TRANSMITTER, RADIO, C11TECHNICAL HANDBOOK - MODIFICATION INSTRUCTIONSUB-TITLE: Replacement of reactor assembly

TRANSMITTER, RADIO, C11

SUB-TITLE: Improved ventilation of modulator valves

SUB-TITLE: Correction of calibrator circuit operation

Fig 1 - Drilling details for housing

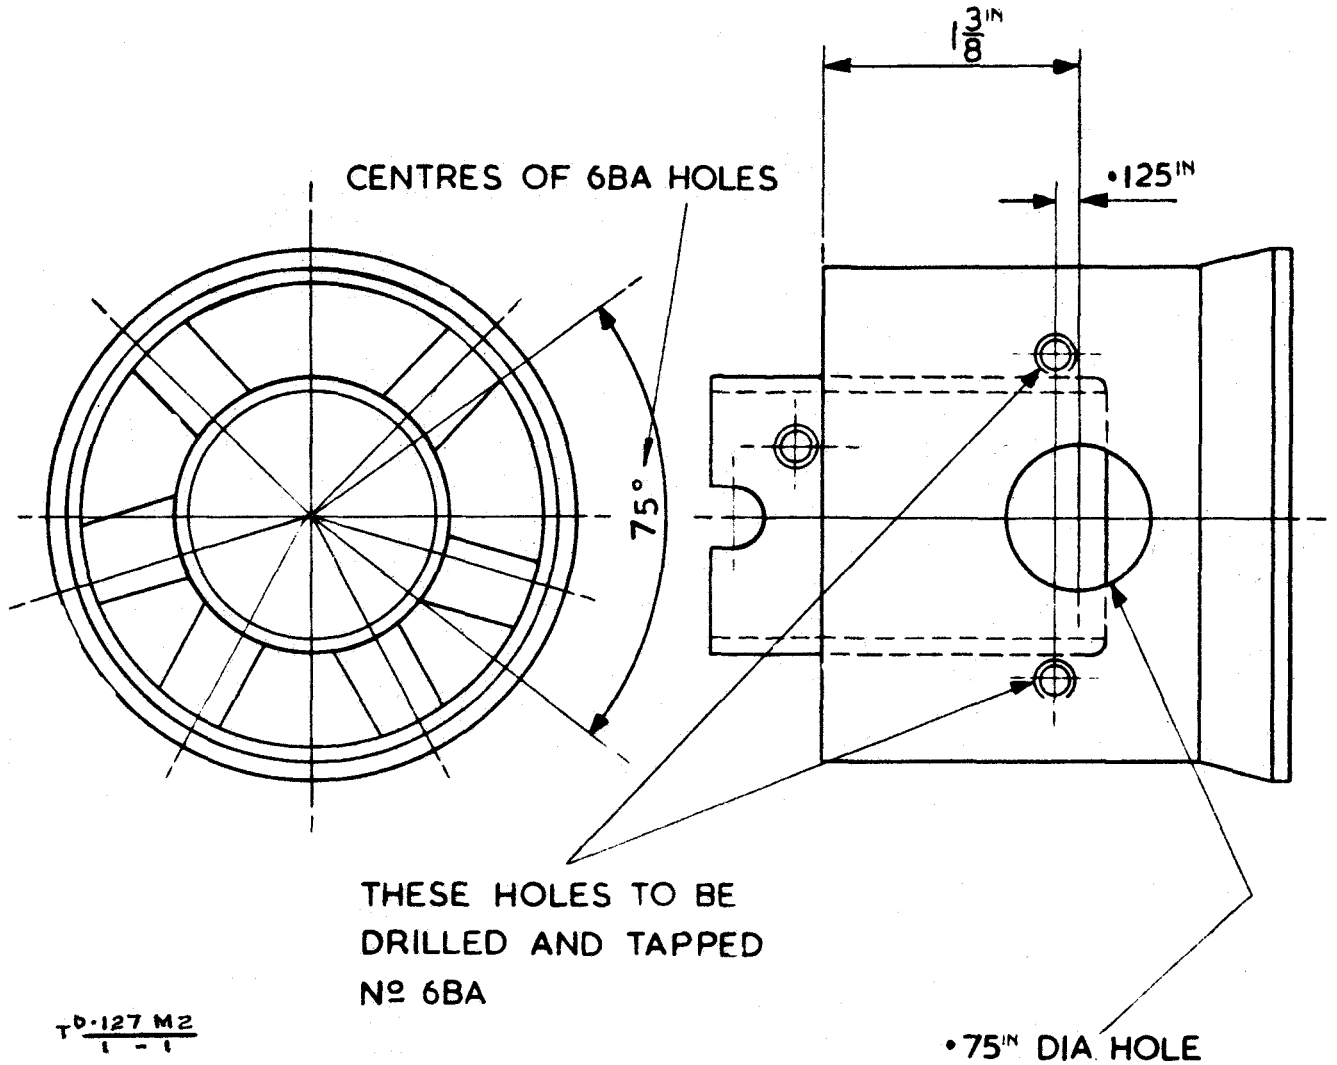
- (d) Drill and tap the blower motor housing as shown at Fig 1. Note that these holes are on the opposite side to the designation plate and on the same side as the red, direction-indicating, arrow.

Fig 2 - Fitting details for scoop

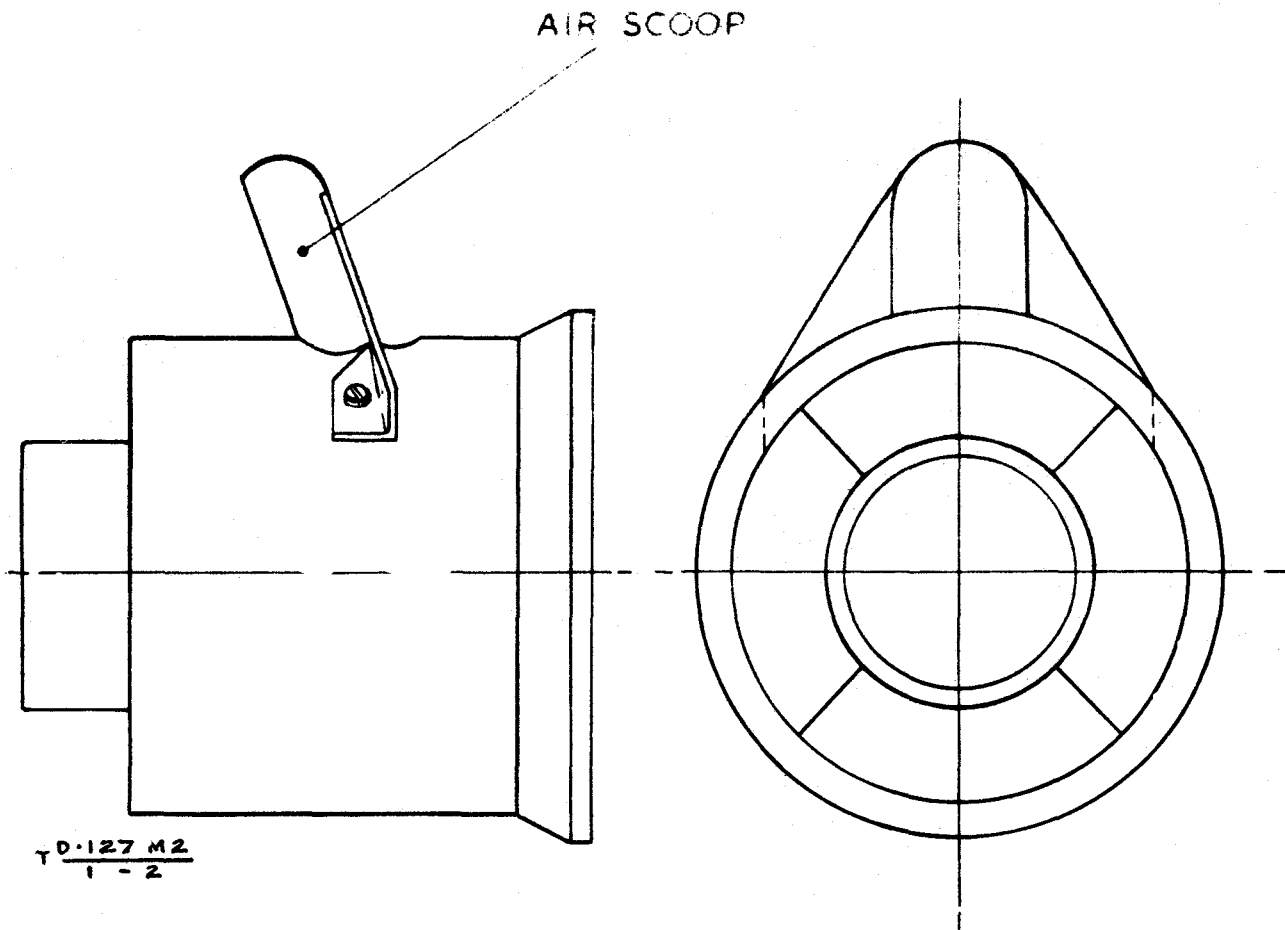
- (e) Fit the Scoop, air flow (ZA 54049) to the housing as shown at Fig 2 using two No 6 BA screws and washers.
- (f) Replace the motor and fan in the blower motor housing and secure with the screws removed at (c). Note that the motor will go in only one way.

Fig 1 - Calibrator (oscillator section)

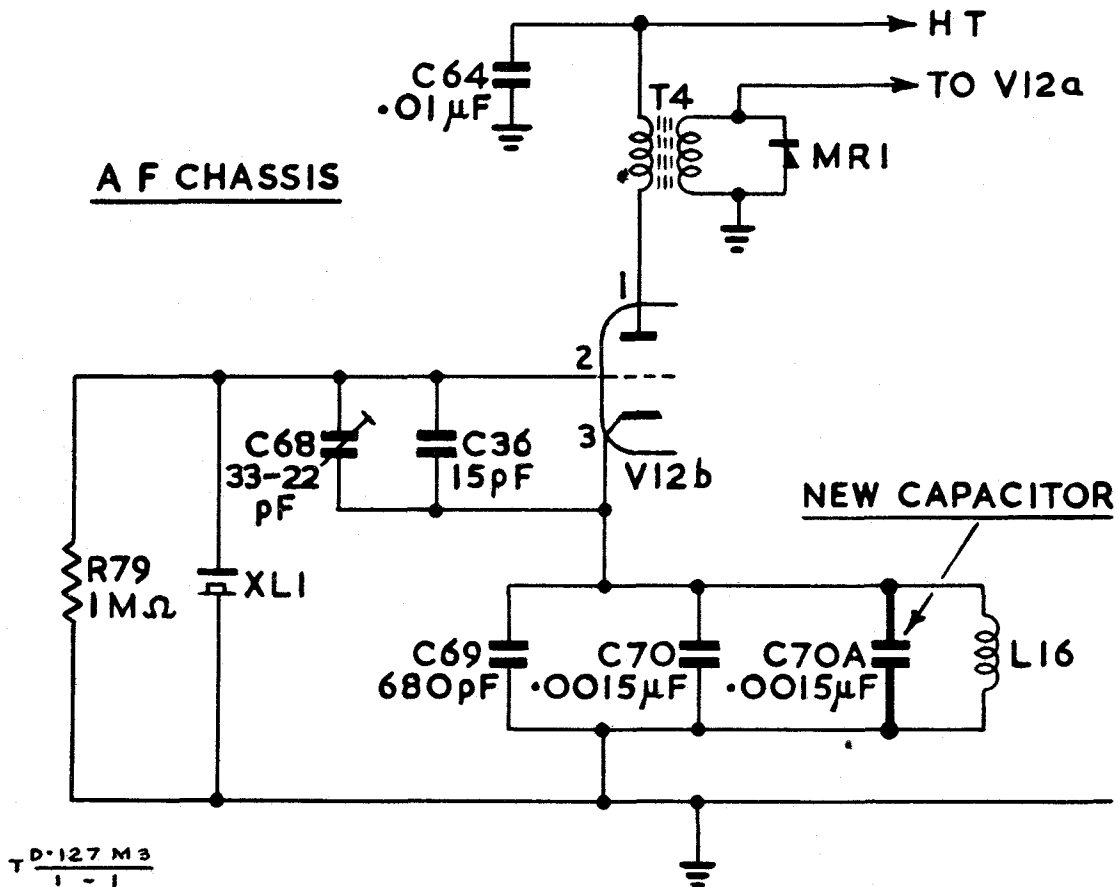
During early production of the Transmitter, radio, C11 it was found that if the system switch S-B was switched rapidly to the INT-CAL position the frequency of the calibrator tended to be determined by the constants of the cathode circuit of the oscillator rather than by the crystal XL1 (100kc/s). This defect was corrected in later production by fitting an additional capacitor across those already existing in the cathode circuit concerned. This regulation gives detail for the modification of early equipments.

- (a) Release the four screws at the rear of the equipment case and withdraw the set.
- (b) Turn the set on its side so that the a.f. unit (which includes the 100kc/s crystal XL1) is uppermost.
- (c) Locate the two capacitors C69 and C70 (680pF and 0.0015μF respectively) which are situated on the tag strips directly below the crystal holder. (See Tels D 122, Part 2, upper diagram of Fig 2011).
- (d) Fit the 0.0015μF capacitor between capacitors C69 and C70 and solder it in parallel with these capacitors. The new capacitor becomes 'C70A'. (see Fig 1).
- (e) Strike through the figure 1 on the equipment modification record plate.
- (f) Replace the set into its case and carry out a complete functional check.
